UNITED STATES PATENT AND TRADEMARK OFFICE

10/822,070

Office Action Summary

ATTACHMENT 1

FIG. 1

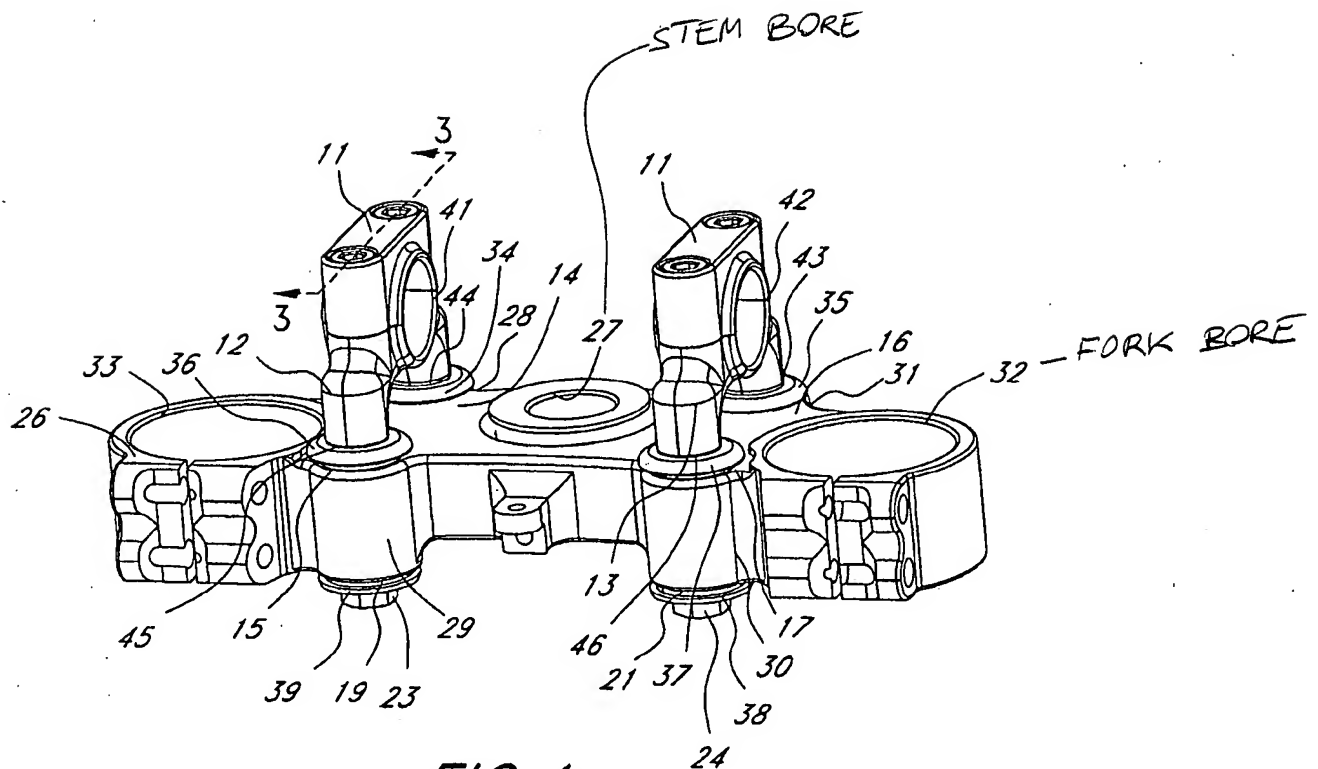
a frame member 26 (see Attachment 1 hereinafter "Att. 1") having a perimeter that comprises a front edge (Att. 1) and a back edge (Att. 1) and having a centerline (Att. 1) between said front and said back edges (Att. 1), comprising,

one or more fork member bores 32, 33 adapted to receive said fork member,
one or more steering stem bores 27 adapted to receive said steering stem;
one or more handlebar support members 11-13 adapted to support said handlebar 10; and
one or more means 22-25 to selectively maintain said handlebar support member 11-13 in one or more selectable positions;

wherein, said frame member 26 has one or more frame engaging parts 14-21 that are adapted to engage, at said selectable positions, one or more handlebar support engaging parts 43-46 provided on said handlebar support member 11-13, and wherein at least two of said selectable positions are inherently between said front edge and said centerline, and at least two of said selectable positions are between said back edge and said centerline.

Regarding Claim 6, see one or more position indicators 34-37. Note that the washers 34-37 are capable of being used to indicate the positions of handlebar support members 11-13 as shown in FIG. 1. Therefore, the washers 34-37 "read on" the claimed position indicators.

FIG. 3

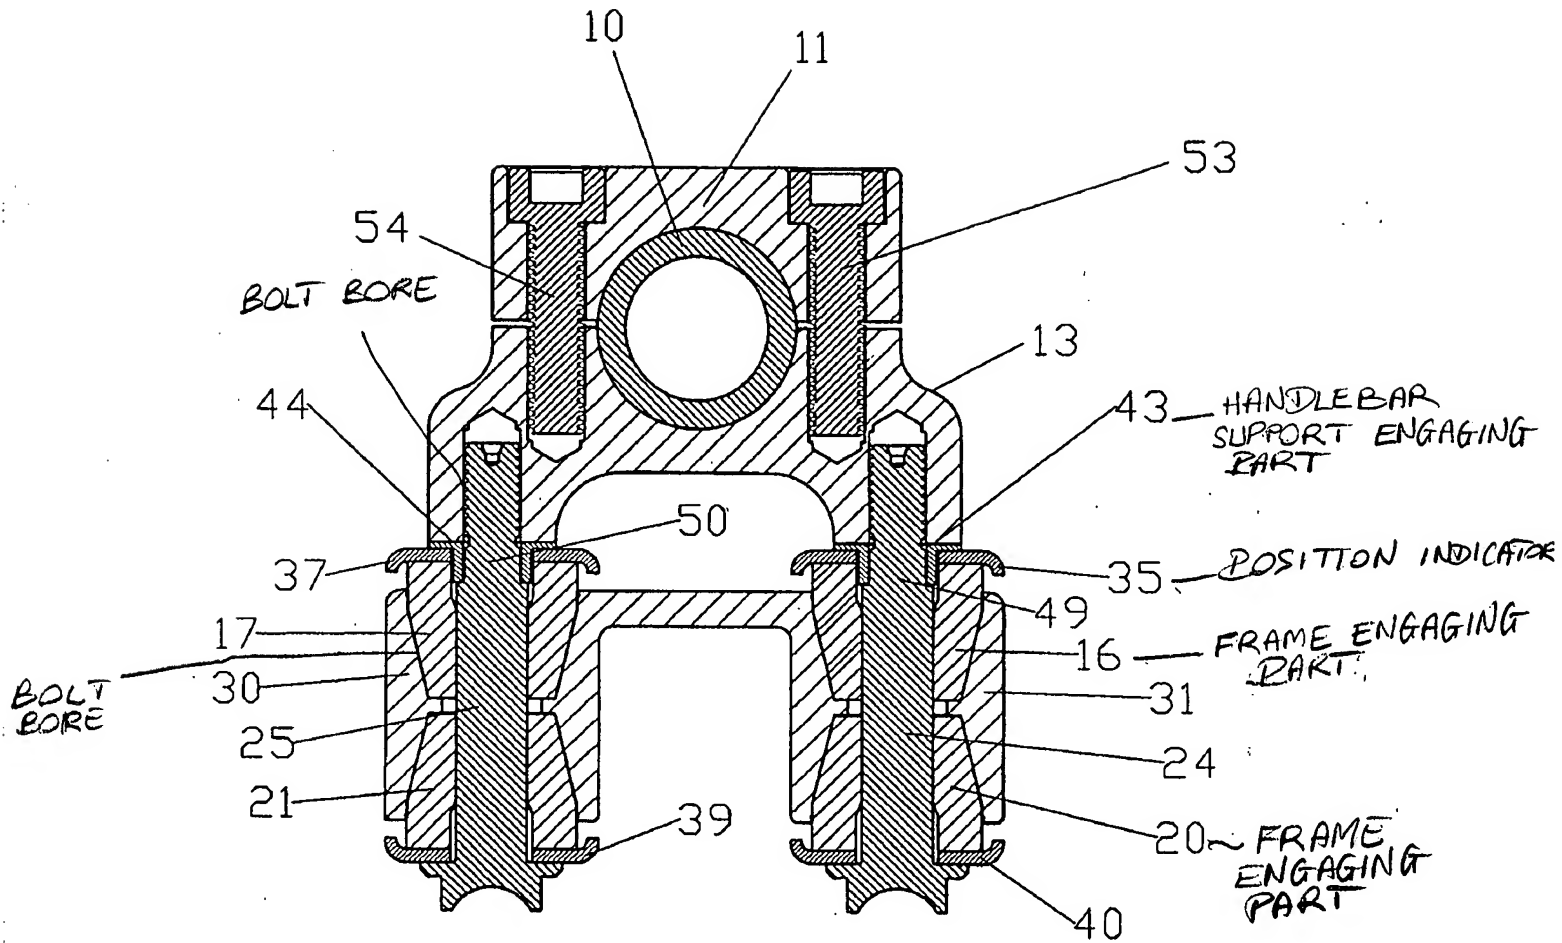
Regarding Claim 1, Henricksen teaches a triple clamp adapted for use with a vehicle having a steering stem (not shown), one or more fork members (not shown), and one or more handlebars 10 (FIG. 3), comprising:

Regarding Claim 2, at least one of said means to selectively maintain said handlebar support member 11-13 comprises, two or more bolts 22-25 that are each adapted to pass through bolt bores 28 and unnumbered (FIG. 3, Att. 1) provided in said handlebar support member 11-13 and said frame member 26.

one or more means 22-25, to selectively maintain said handlebar support member 11-13 in one or more of said selectable positions, comprising, two or more bolts 22-25 each adapted to pass through bolt bores 28 (FIG. 3, Att. 1) provided in said handlebar support member 11-13 and said frame member 26;
